Circular No. 247/2023

FSN of EVIS EXERA III GASTROINTESTINAL VIDEOSCOPE from Olympus Corporation of the Americas.

URGENT FIELD SAFETY NOTICE

RE: EVIS EXERA III GASTROINTESTINAL VIDEOSCOPE OLYMPUS GIF-1TH190

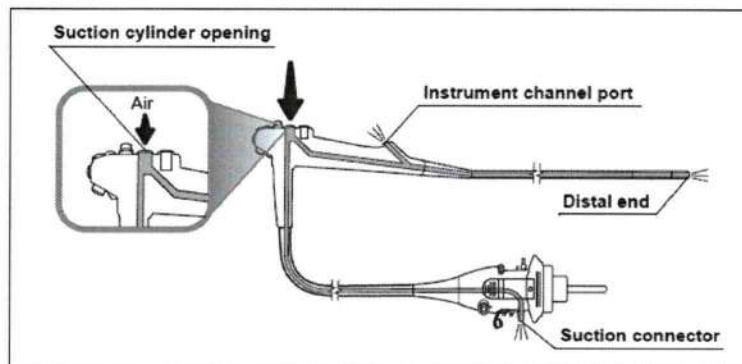
1. Cover the distal end, the control section, and the endoscope connector of the endoscope with sterile lint-free cloths to prevent splashing alcohol or water from the channel openings.

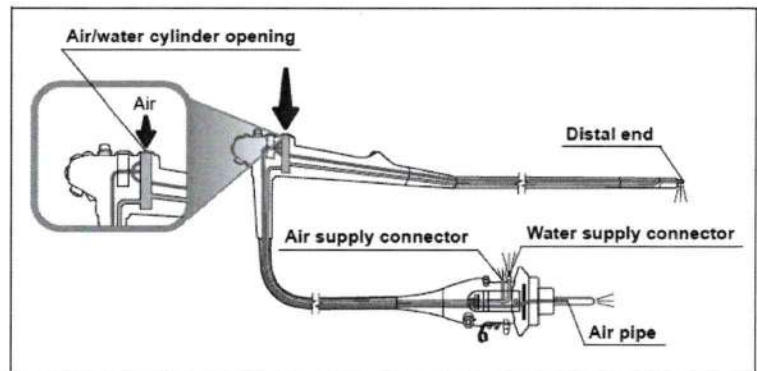
2. Supply compressed filtered air at a pressure of 0.2 – 0.5 MPa into the suction cylinder opening until no alcohol or water exits from the distal end, the instrument channel port, or the suction connector. Supply compressed air for 3 minutes minimum for alcohol and 90 seconds minimum for water.

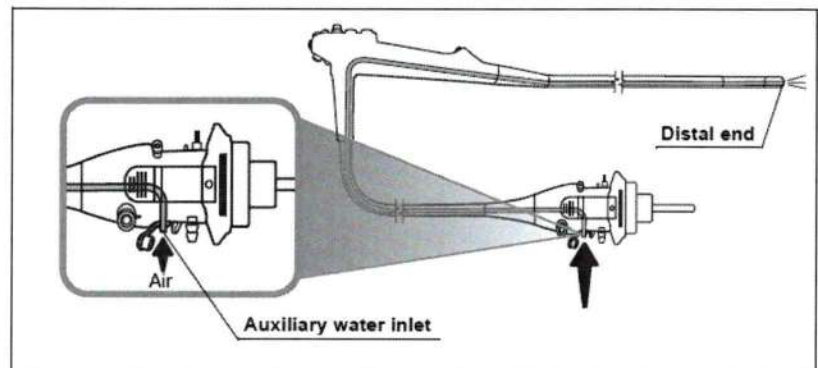
3. Supply compressed filtered air at a pressure of 0.2 – 0.5 MPa into the air/water

cylinder opening until no alcohol or water exits from the distal end, the air supply connector, the water supply connector, and the air pipe of the endoscope. Supply compressed air for 3 minutes minimum for alcohol and 90 seconds minimum for water.

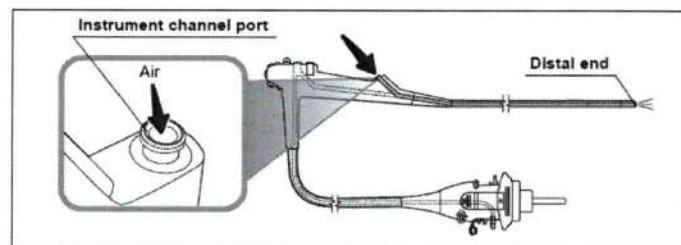
4. Supply compressed filtered air at a pressure of 0.2 – 0.5 MPa into the auxiliary water inlet until no alcohol or water exits from the distal end of the endoscope. Supply compressed air for 3 minutes minimum for alcohol and 90 seconds minimum for water.

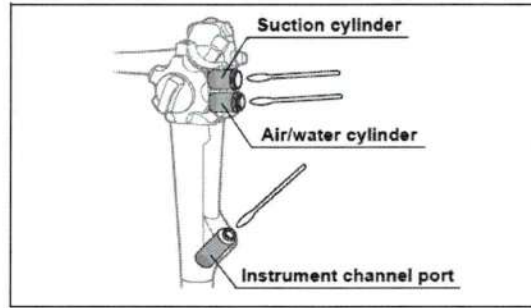
5. Supply compressed filtered air at a pressure of 0.2 – 0.5 MPa into the instrument channel port until no alcohol or water exits from the distal end of the endoscope. Supply compressed air for 3 minutes minimum for alcohol and 90 seconds minimum for water.

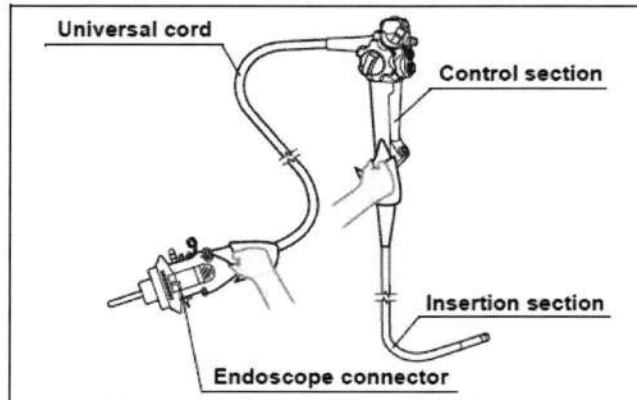
6. Thoroughly dry the inside of the suction cylinder, the air/water cylinder, and the instrument channel port of the endoscope, using sterile cotton swabs.
